## Delta Projects C/ Future Urban

Construction of a five story residential flat building comprising ground level retail tenancies with residential apartments above and basement and ground level car parking accessed from Pulsford Road

### 69-73 Prospect Road, Prospect

050/M006/19

Figure – 3 Ground level setback (northern side)

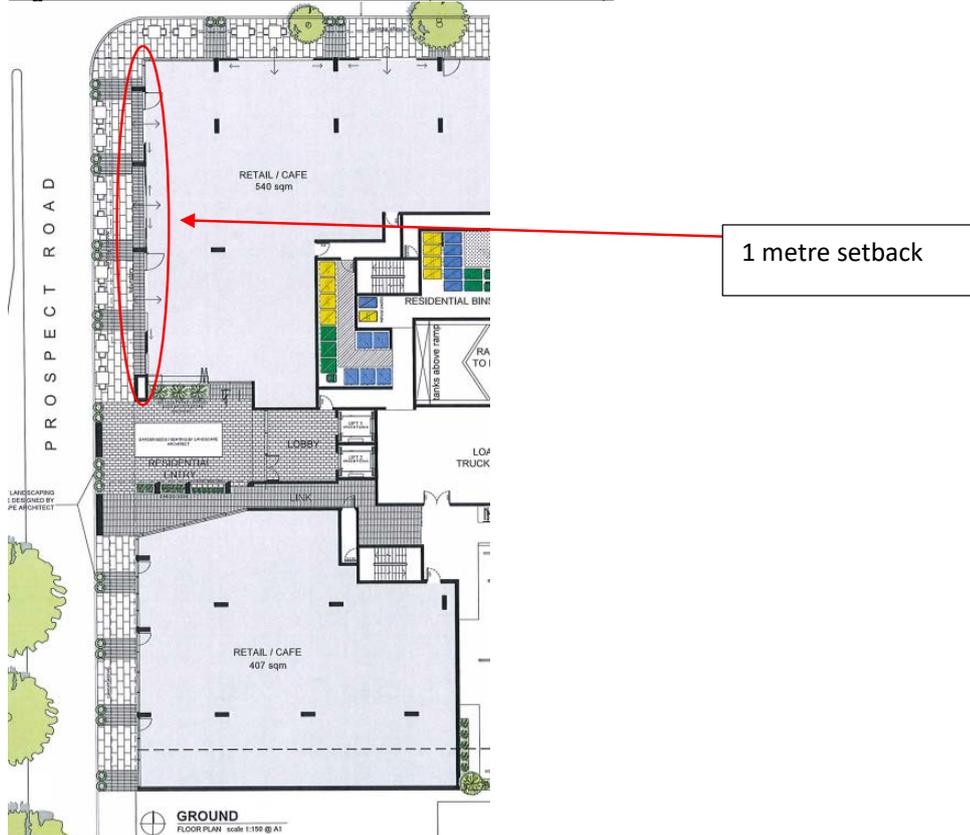
In this case, the development is considered to contribute to the retail function anticipated with two large tenancies at ground that sleeves car parking and exceeds the 60% minimum sought for the street frontages, as desired by PA PDC 5. While narrow-frontage tenancies are not proposed at ground, the development is consider to respect the continuous built form edge to the street and provides a consistent footpath edge envisaged for Prospect Road. The GA has indicated strong support for the widening of the footpath that provides a generous and usable public plaza and increase in activation by setting back the northern half of the ground floor façade along Prospect Road (Figure 3 below).

While the 4 storey street wall height exceeds that desired (2 storeys/up to 8 metres), the GA is of the view that the street wall proposed reinforces the high street character of Prospect Road. The four storey masonry wall includes a built form break at the centre of the Prospect Road frontage through the provision of a recessed residential entry. The composition of the fifth level, setback above the 4 storey street wall (3.5 metres), is also supported by the GA. The fifth level is considered restrained in its expression and is considered different from the four storey built form below, reducing its visual impact.

Figure 5 – Overlooking detail, eastern facade

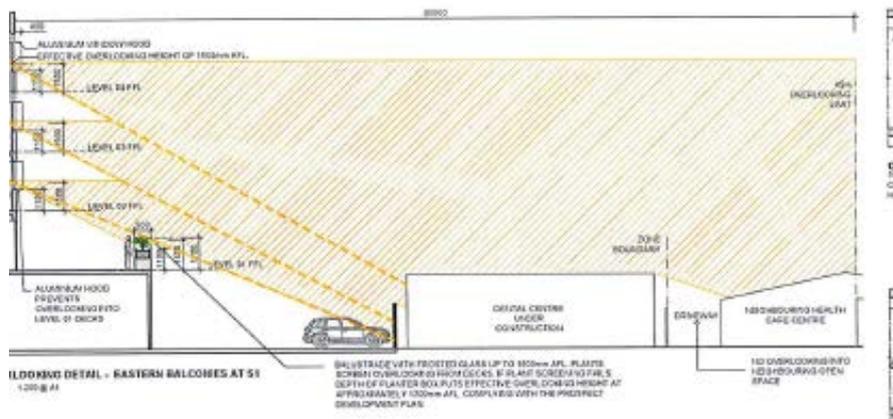
In this case, the applicant has provided drawings that show how overlooking into adjacent sites (within 45 metres from the source of overlooking rather than the site boundary) will be minimised with:

- High level windows or frosting to the lower portion of glass for those windows that face east;
- Window hoods, planter boxes or fixed blades to eastern balconies that restrict views from a height of 1.5 metres AFL;

Council has indicated that while the proposed visual privacy treatments are supported in concept, additional detailed information was required in order to complete a full assessment of these treatments and their success (or otherwise) at preventing overlooking to Residential Zone properties within 45 metres of the subject site (consistent with PDC 8 of the UC Zone). The applicant's planning consultant has reviewed the Council concern and has outlined in regards to overlooking that:

While it is acknowledged the design of screening does not 'prevent' overlooking within 45 metres from the site boundary as desired by Zone PDC 9, it is considered that the screening measures will ensure an appropriate level of privacy (from the source of overlooking) for the one dwelling located within the 45 metre range of the site. The screening devices proposed will prevent direct views in the Private Open Space (POS) of this adjacent property in Milner Street as shown in Figure 6 above. As outlined above and in the PLA advice, the GA supports the proposed methods of screening that is considered to mitigate detrimental interface impacts while maintaining amenity for the apartment residents.

Figure 6 – Overlooking detail, southern facade

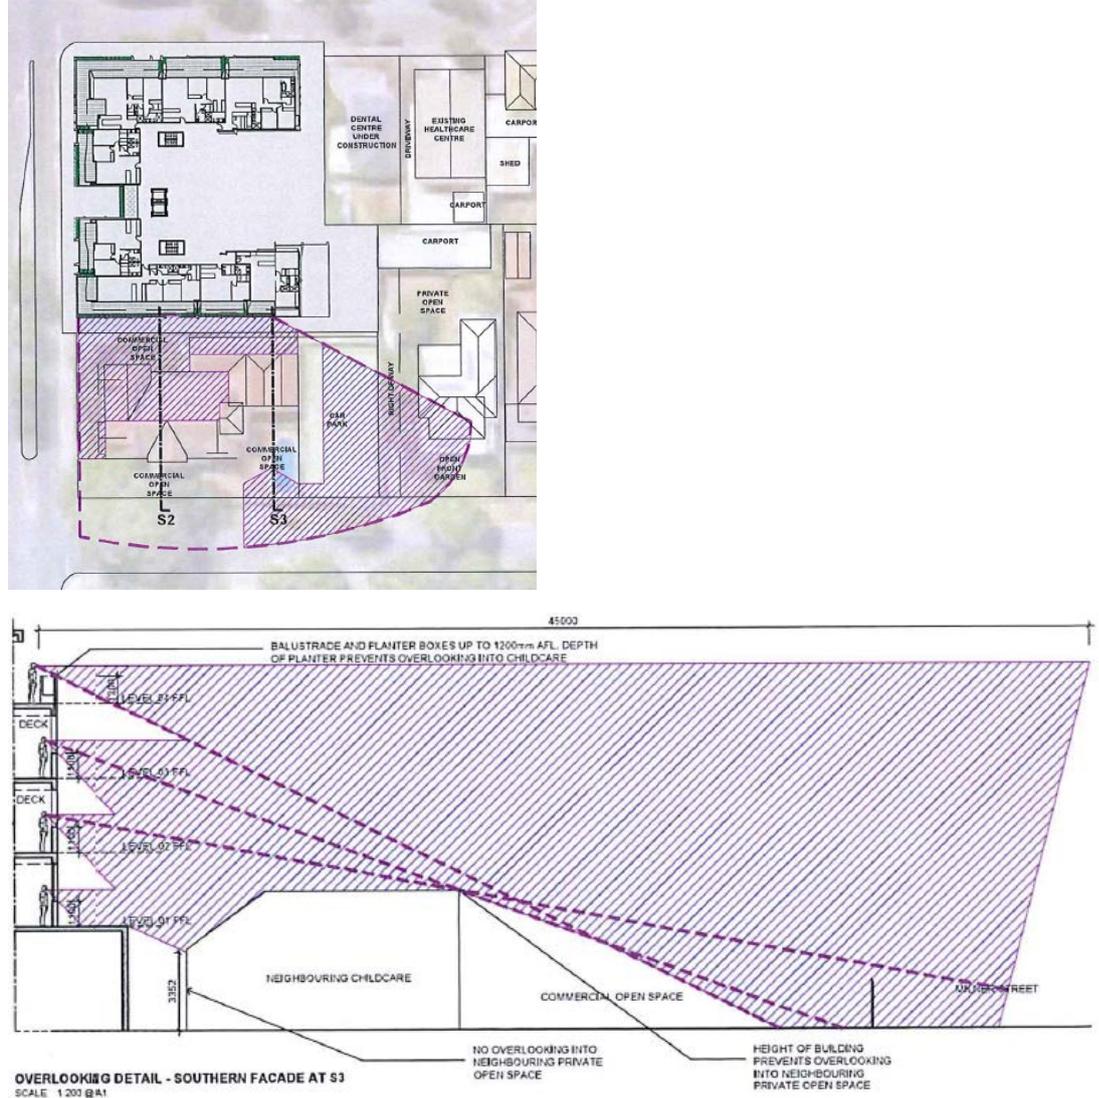
- 1.2m AFL balustrades and 1m depth of planter boxes preventing direct views to the south and south-east from the upper level balcony (sections 2 & 3)

**Figure 7 - Ground Floor Landscape Plan**

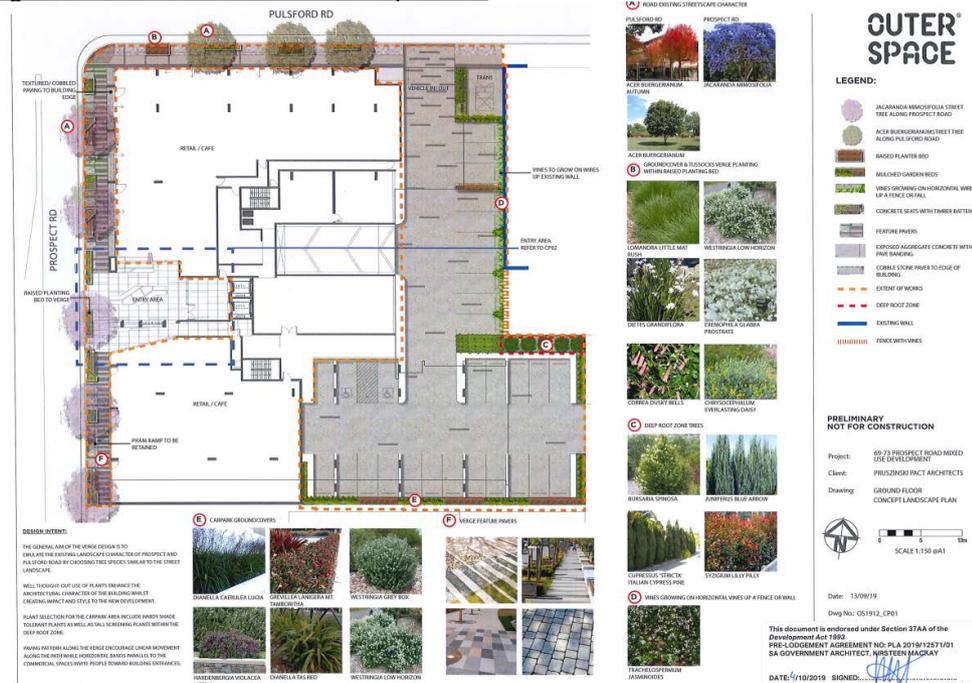
To achieve this, Council Wide PDC 180 & 181 seek deep soil zones that can accommodate deep root vegetation with access to natural light (to assist with maintaining vegetation health), including tall trees with large canopies. Having said this, the Desired Character of the High Street Policy Area also recognises that landscaping and other green infrastructure will be primarily confined to areas within the public realm and in accordance with the Prospect Road Master Plan, on buildings (rooftop, walls and verandahs), within rear yards, on zone boundaries.

For sites such as this that exceed 1500m<sup>2</sup>, a minimum of 7% deep soil area should be provided with a minimum dimension of 6m x 6m. One (1) large or medium tree per 60m<sup>2</sup> of deep soil should also be provided that has a height of 6-12+ metres. In this case, the development dedicates approximately 1%/33m<sup>2</sup> of the site in area 'C' for deep soil landscaped areas, which is shown in the plan provided by Outer Space above. The deep soil areas provided for this development includes a 33m<sup>2</sup> (2.2m x 15m area) within the rear car park, with landscaping also provided around the side and rear perimeter of this car parking area. It is also proposed that common areas and private balconies will be landscaped as shown below in Figures 8 & 9.

While the proposal has a significant shortfall in deep root areas (6%/165m<sup>2</sup> shortfall), it is considered that the overall development will provide a good level of amenity for the occupants via private and public landscaping that will also contribute to the Prospect and Pulsford Road public environment.
